UNITED STATES OF AMERICA

NUCLEAR REGULATORY COMMISSION

Application of SOUTHERN CALIFORNIA	)	Docket No. 50-361
EDISON COMPANY, <u>ET AL.</u> for a Class 103	)	
License to Acquire, Possess, and Use	)	
a Utilization Facility as Part of	)	Amendment Application
Unit 2 of the San Onofre Nuclear	)	No. 136
Generating Station	)

DESCRIPTION AND SAFETY ANALYSIS  
OF PROPOSED CHANGE NPF-10/15-429

SONGS 2 & 3	
SAN ONOFRE NUCLEAR GENERATING STATION	
LOGIC DIAGRAM CLASS 1E 4.16KV BUS UNDERVOLTAGE DETECTION	
	SOUTHERN CALIFORNIA EDISON
FIGURE 1

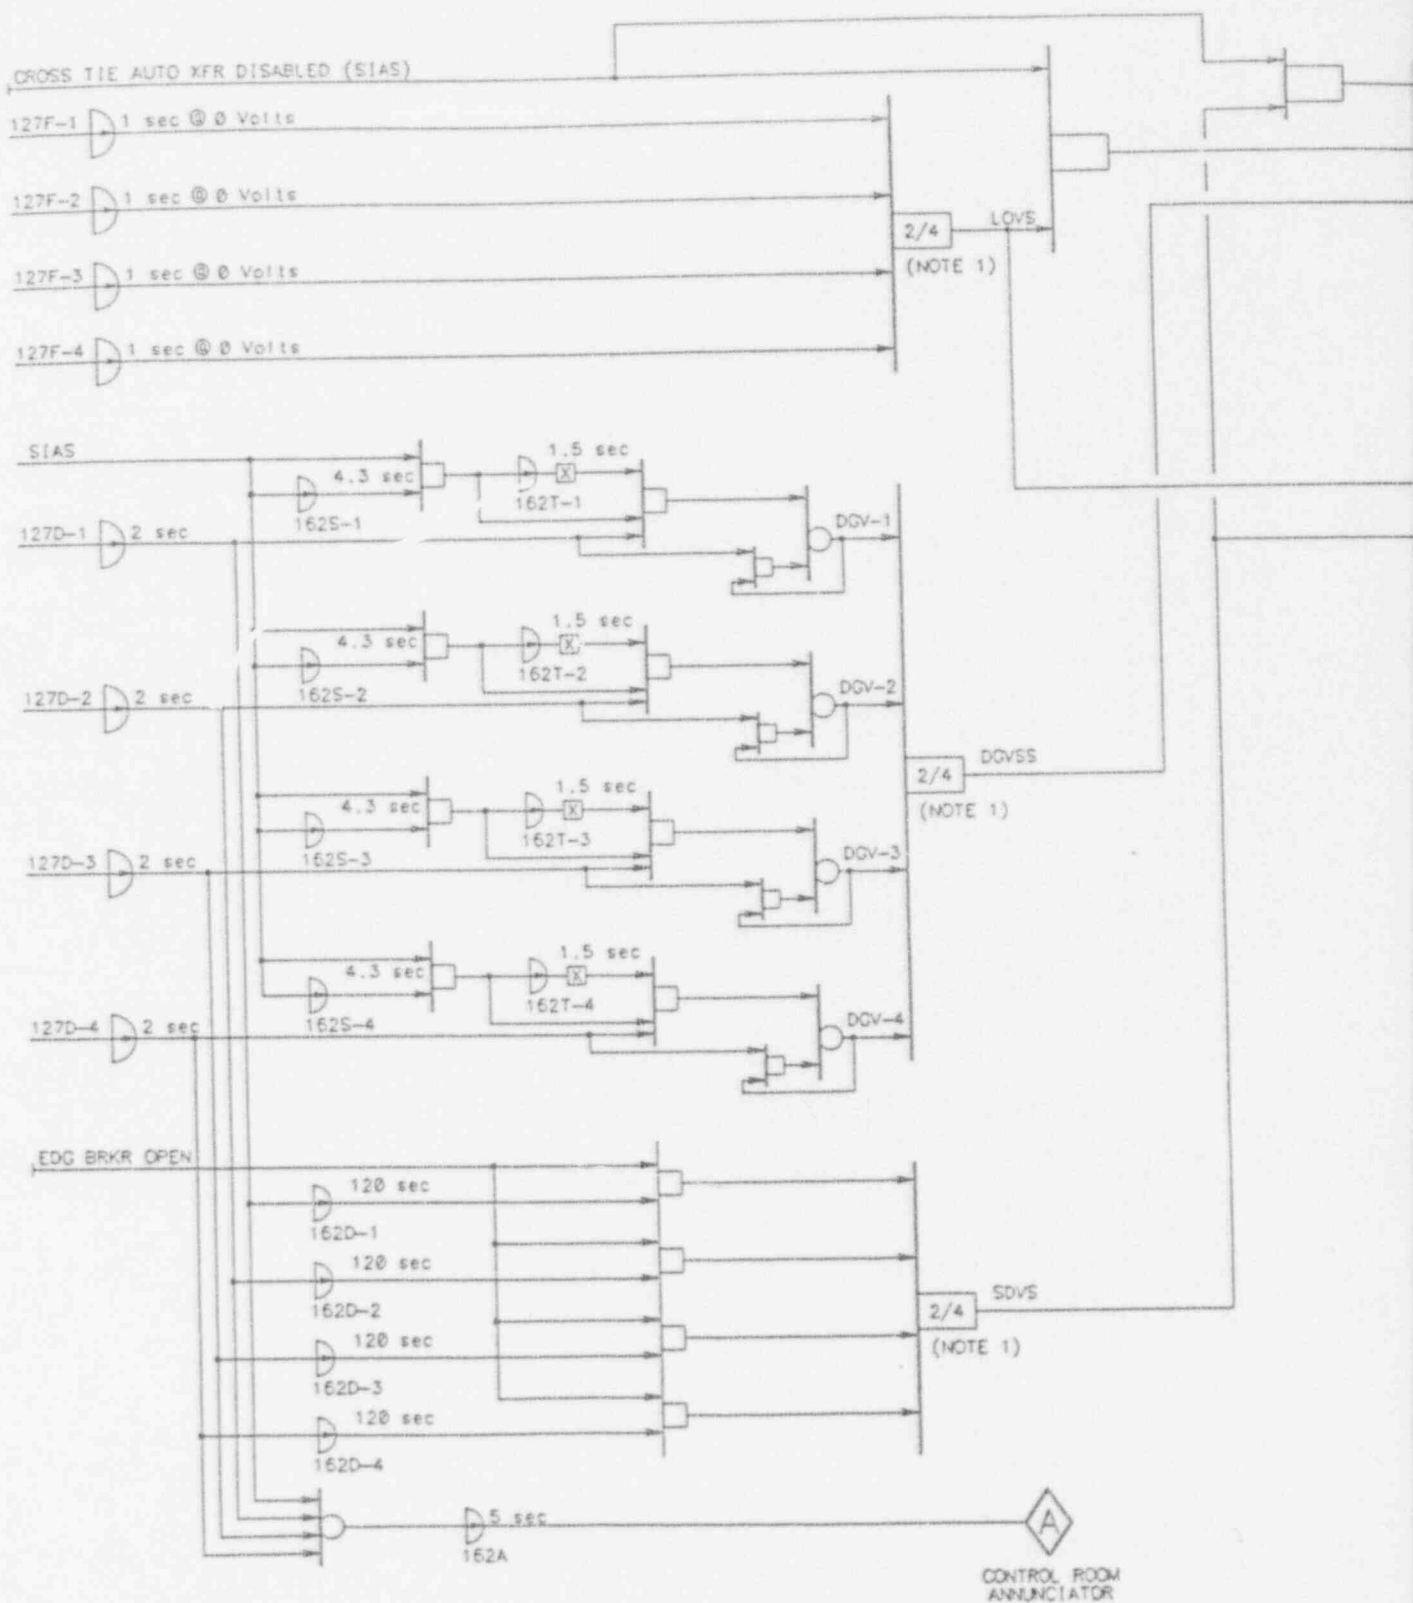
standby power source in case of a SIAS with a loss of voltage or degraded voltage condition, SCE is planning to modify the existing LOVS logic and install a separate degraded voltage protection scheme. The logic diagram for the new configuration is shown in Figure 1.

The degraded voltage condition will be detected by new definite time delay solid state relays 127D1, 127D2, 127D3, and 127D4. These relays will be connected to the same set of bus potential transformers as the existing relays 127F1, 127F2, 127F3, and 127F4. The new 127D relays are set at 4228 V, with a definite time delay setting of 2.0 seconds. This voltage setting will assure adequate voltage at the terminals of all engineered safety features equipment based on a switchyard minimum allowable voltage of 218 kV. The voltage setting of 4228 V is below the voltage normally expected at the 4.16 kV level (4360 V or above) with switchyard voltage of 230 kV. Therefore, under normal operating conditions a spurious actuation is not expected.

The new relays, in conjunction with the timing relays 162S1 and 162T1, 162S2 and 162T2, 162S3 and 162T3, and 162S4 and 162T4, will provide the Degraded Grid Voltage with SIAS Signal (DGVSS). The voltage and time delay settings are such that a sensing window will open with a time delay of approximately 4.3 seconds after initiation of SIAS. This window will remain open for approximately 1.5 seconds, during which time a DGVSS will be initiated if a degraded voltage condition is established. Upon initiation of the DGVSS, the 4.16 kV Class 1E buses will be transferred directly to the standby power source rather than to the alternate preferred power source, which is likely to also be experiencing a degraded voltage.

The 4.3 second time delay for this signal is initiated by SIAS, and is independent of the time delay chosen for sustained degraded voltage protection. This time delay is chosen to 1) ride through the voltage transients and 2) to ensure that adequate voltage is available on the Class 1E bus during post-accident emergency safety feature load sequencing. Following acceleration of the first load group during post-accident load sequencing, the degraded voltage scheme will have an approximately 1.5 second window in which to sense the voltage on the 4.16 kV Class 1E bus. If the voltage is below the degraded voltage setpoint, the Class 1E bus will separate from the preferred power source and transfer to the standby power source.

UNITS 2 & 3	
SAN ONOFRE NUCLEAR GENERATING STATION	
ONE LINE DIAGRAM OF LOAD GROUP A POWER SOURCES	
	SOUTHERN CALIFORNIA EDISON
	FIGURE 2

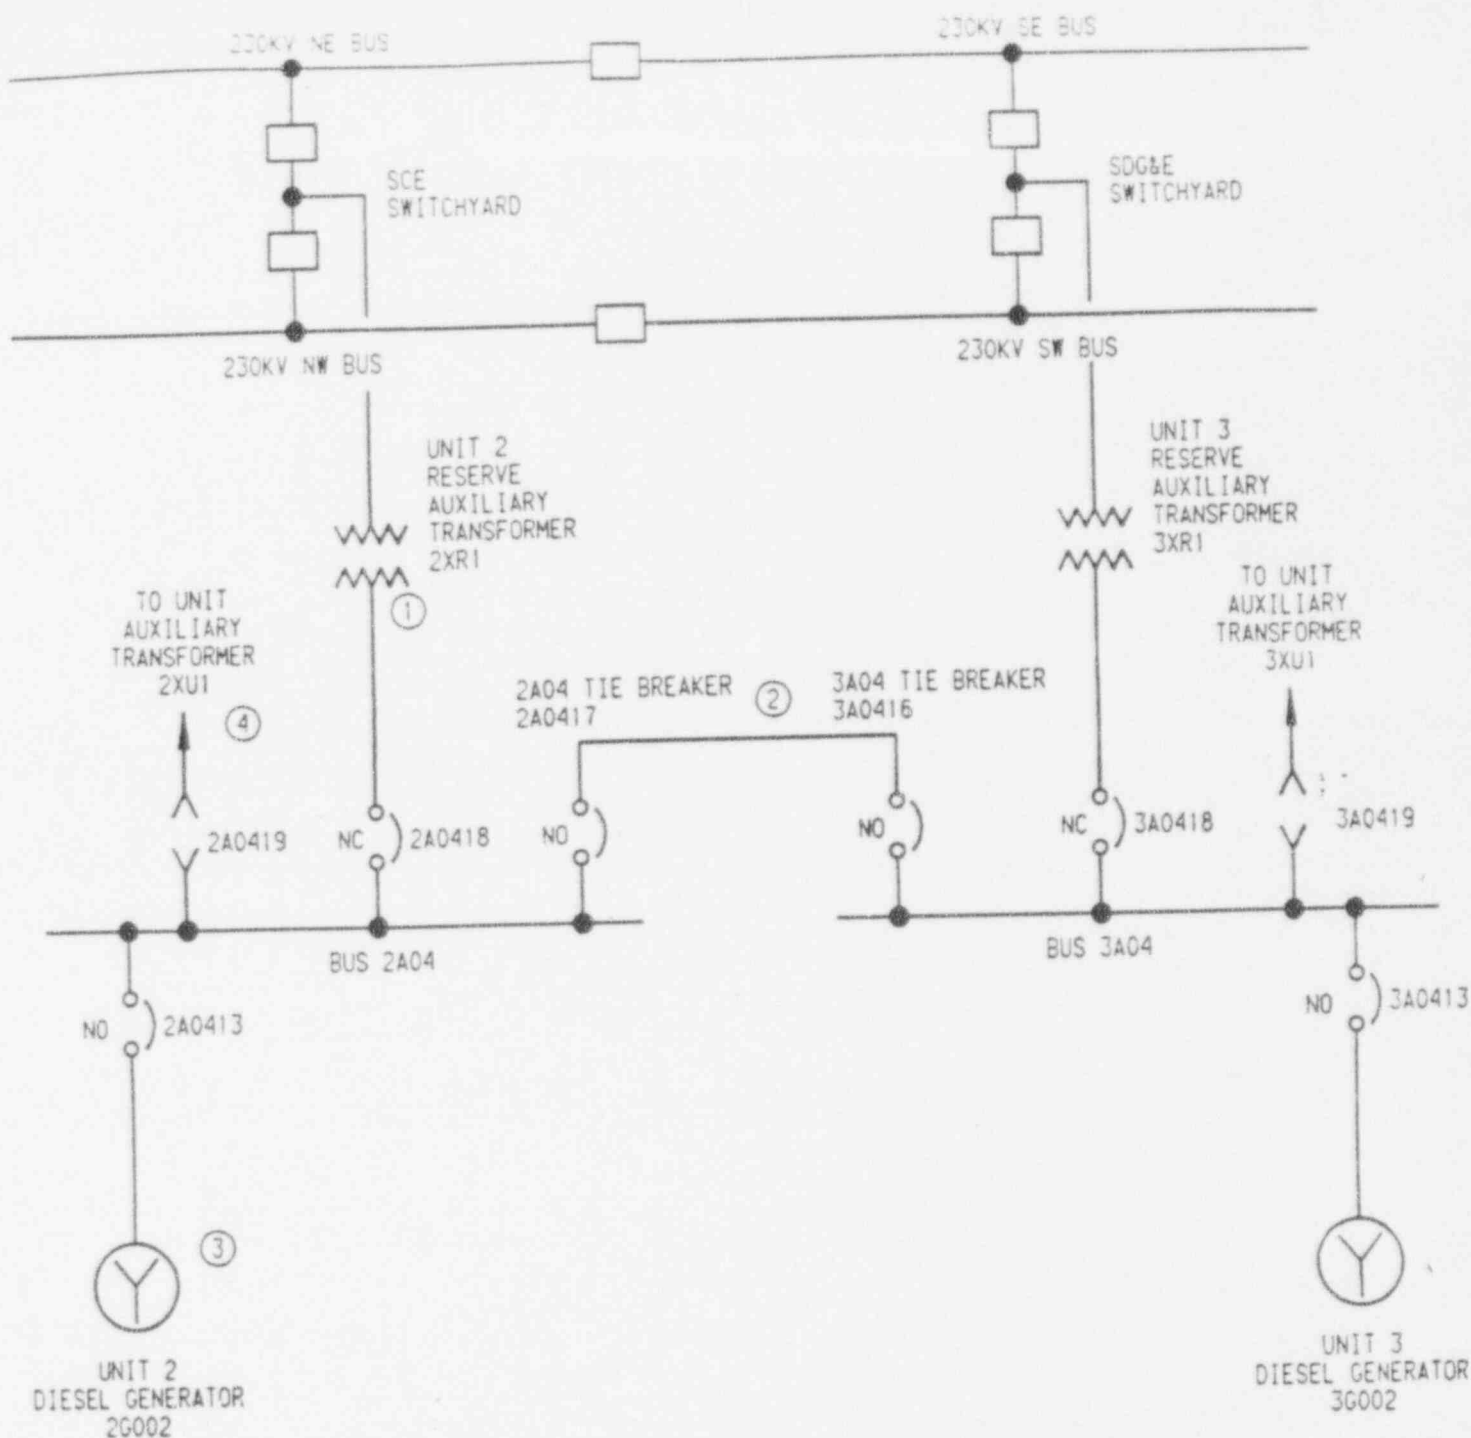
The power sources to the Train A Class 1E 4.16 kV buses for SONGS Units 2 and 3 are provided in Figure 2. Train B has the same configuration.
